Access Compliance Report Public Rights-of-Way (Curb Ramps)

Main Street: CHADWICK_LN Cross Street: MARBLE_ARCH_DR Location: SW

ADA ID: RPRK211012131137 Ramp Type: Type 7 - Directional 2 Initial Pass/Fail: Fail Overall Compliance: No Severity Score: 30

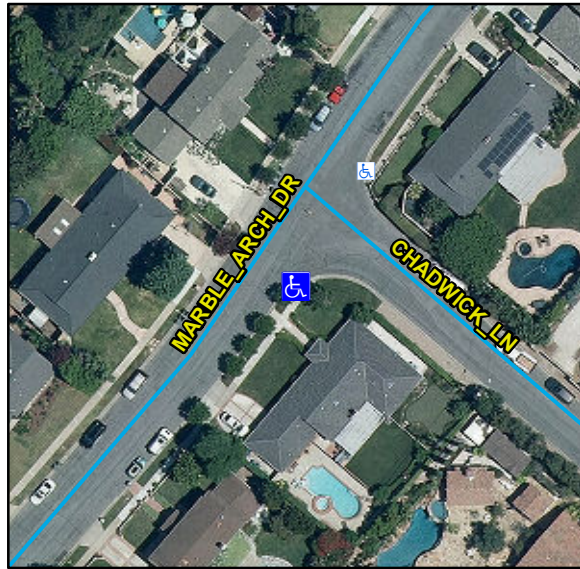
Compliance	Description	Data	Compliance	Description	Data
N/A	Ramp Length (in)	1	N/A	Flare Type LT	
Yes	Ramp Width (in)	64			N/A
Yes	Ramp Run Slope (%)	6.3	N/A	Flare Slope LT (%)	N/A
No	Ramp Cross Slope (%)	8	N/A	Flare Traversable LT	N/A
N/A	Grade Break	N/A	N/A	Flare Type RT	
N/A	Grade Break Slope (%)	N/A			N/A
N/A	Grade Break Cross Slope (%)	N/A	N/A	Flare Slope RT (%)	N/A
	Addl Para Ramp Left?	No	N/A	Flare Traversable RT	N/A
	Addl Para Ramp Right?	No	N/A	DWS Provided	N/A
N/A	Landing Present	N/A	N/A	DWS Contrast	N/A
N/A	Landing Length (in)	N/A	N/A	DWS Length (in)	N/A
N/A	Landing Width (in)	N/A	N/A	DWS Full Width	N/A
N/A	Landing Run Slope (%)	N/A		DWS Offset Type	N/A
N/A	Landing Cross Slope (%)	N/A	N/A	DWS Left Offset (in)	N/A
N/A	Landing Movement Obstructed?	N/A	N/A	DWS Right Offset (in)	N/A
	Landing Movement Type	N/A			
N/A	Landing Shared	N/A			
N/A	Marked Crosswalk 1	No	N/A	Clear Space	N/A
	Crossing 1 Direction	NE	N/A	Clear Space To Crosswalk (in)	N/A

Remove & Replace Entire Ramp.
